Integration of Information system, FUA update

Mr. KAWAGUCHI Yoshio
Radiation Monitoring Division,
Radiation Protection Department,
Nuclear Regulation Authority, JAPAN

May 26, 2025 (IAEA review mission)

Consideration for integration of Sea Area Monitoring Data(2 of 2)

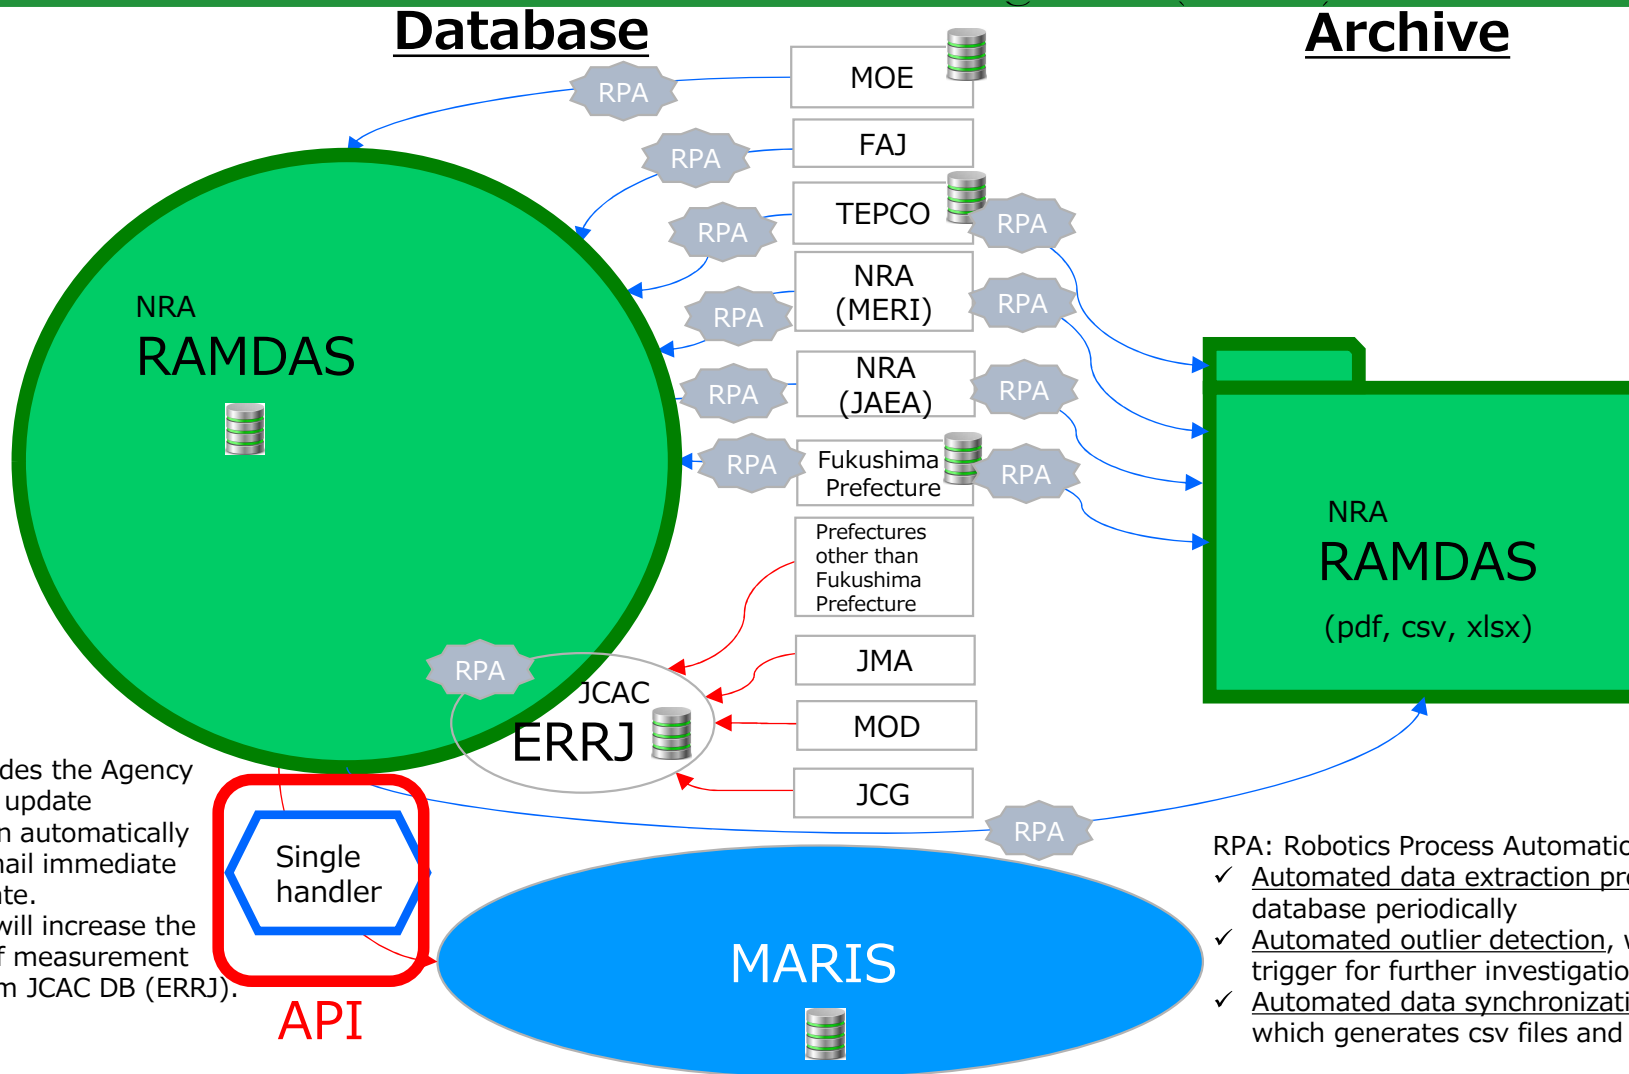
Based on IAEA Task Force members' comments from the previous Review mission, **The IAEA Task Force recognizes that Government of Japan still needs to integrate up-to-date monitoring data.**

➤ NRA considers to **integrate the information of each DB** in the portal site of the RAMDAS with an interface that is highly compatible with the IAEA's next-generation DB.

- ✓ Automated data extraction process, which feeds data to database periodically
- ✓ Automated outlier detection, which gives alert to NRA as a trigger for further investigation
- ✓ Automated data synchronization between DB and Archive, which generates csv files and sends them to archive

- ✓ NRA provides the Agency with a DB update notification automatically through email immediately after update.
- ✓ RAMDAS will increase the number of measurement points from JCAC DB (ERRJ).

Project Schedule

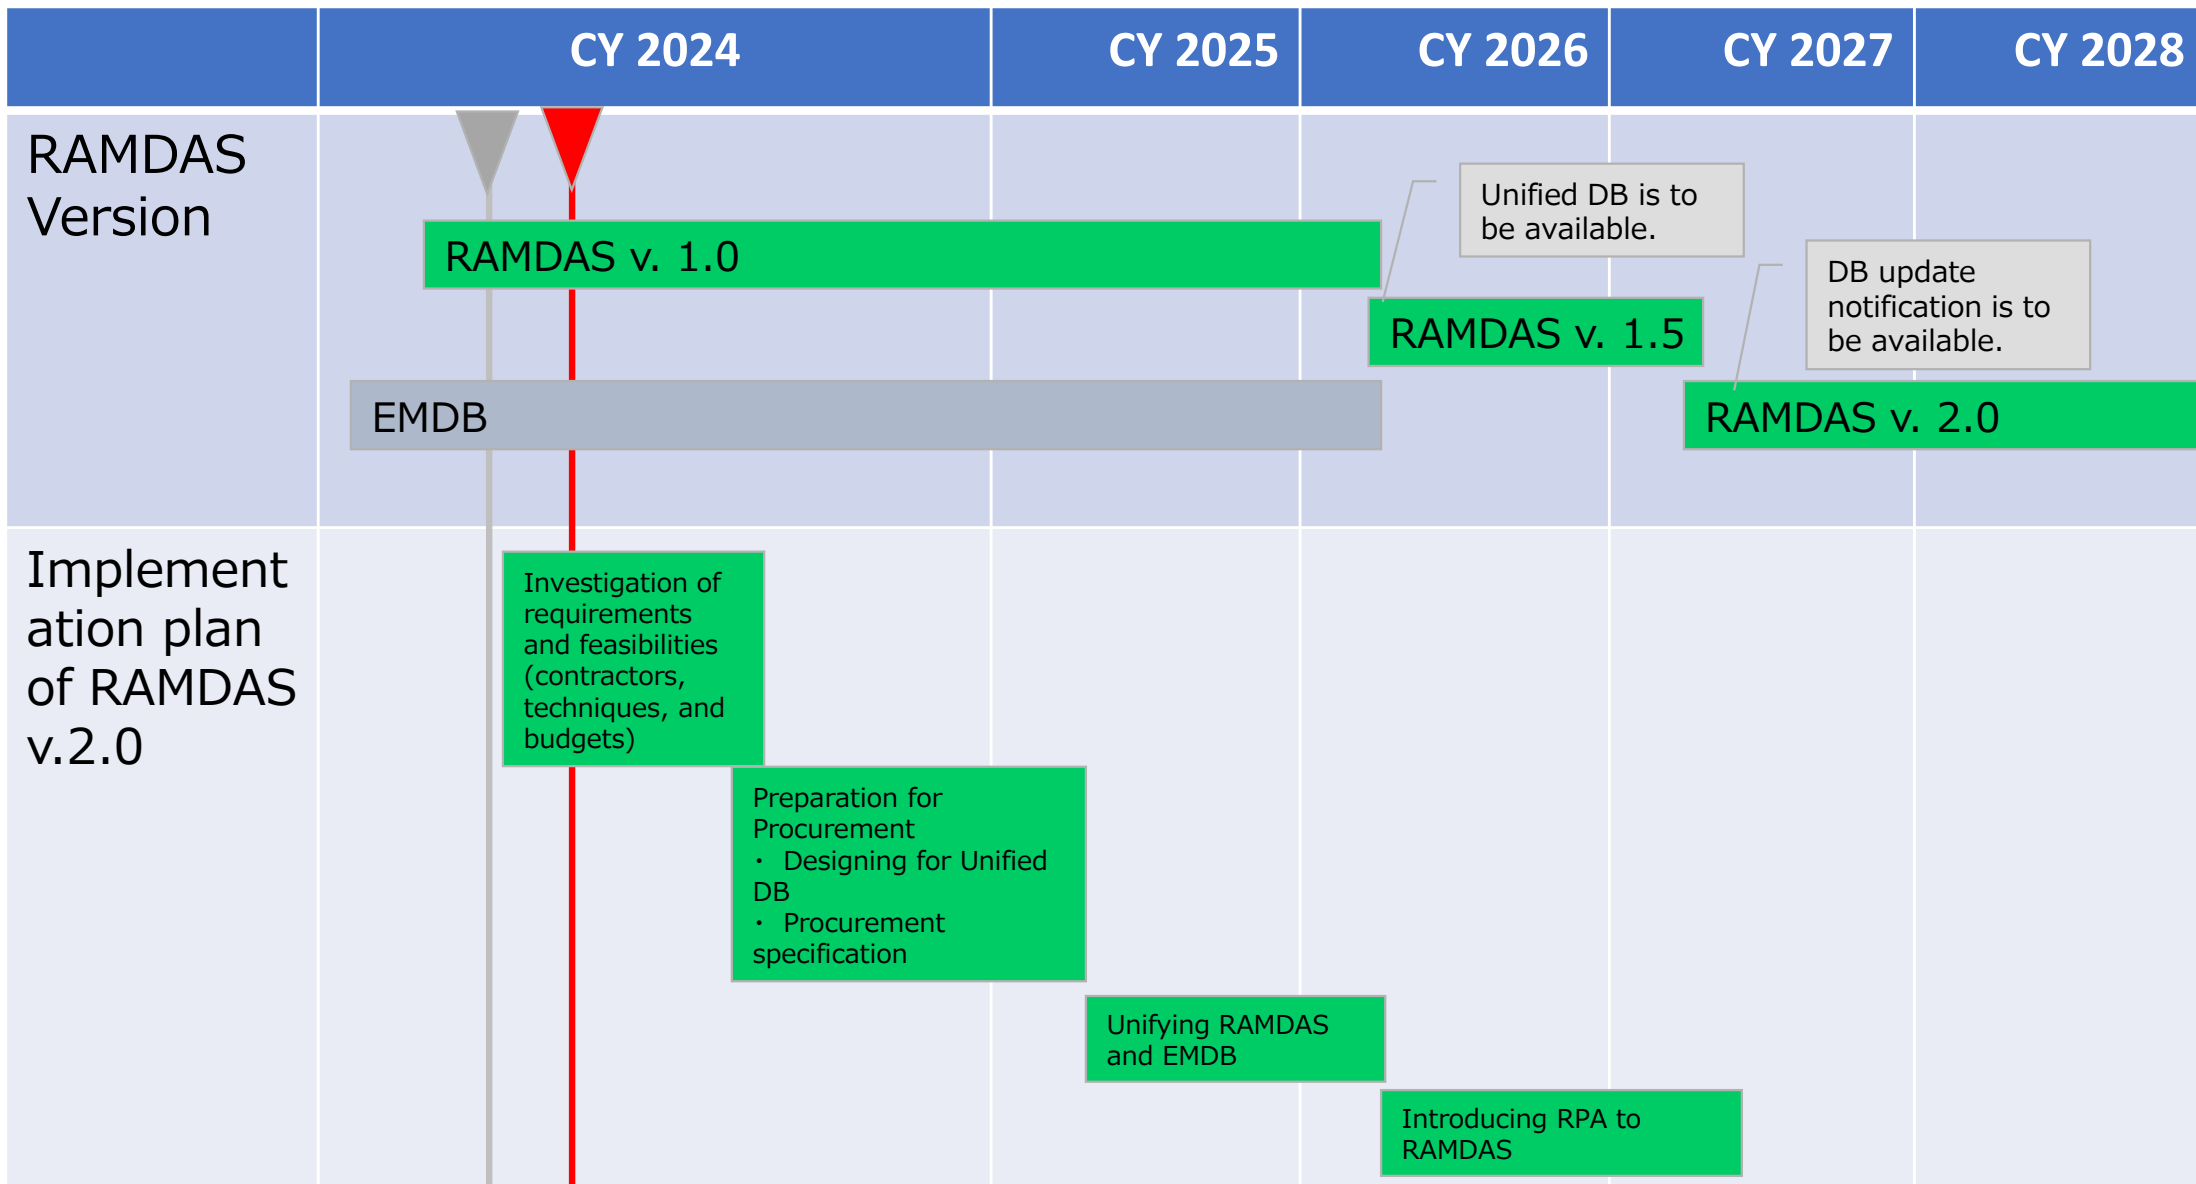
- The Task Force recommended accelerating the timeline for the development of a comprehensive website that includes all monitoring and analysis results.
- NRA presented plans for a new comprehensive system that would address the Task Force's recommendation from the previous mission that a comprehensive website containing all the monitoring and analysis results would be beneficial for the public and help to streamline the access and consumption of relevant data.
 - The Task Force welcomed this initiative but expressed some concern about the proposed timeline, with completion not expected until April 2027.

- Based on the Task Force's intention to accelerate the development, NRA decided **to provide data to MARIS via API by the end of FY2025 (until April 2026)**. This will consolidate all monitoring data on the IAEA's website, MARIS. NRA will strive to make the marine monitoring data of ALPS-treated water as accessible as possible.

However, due to technical challenges and budget constraints, NRA plans to maintain the schedule to develop systems for automatic data extraction from individual databases by the end of FY2026 (April 2027).
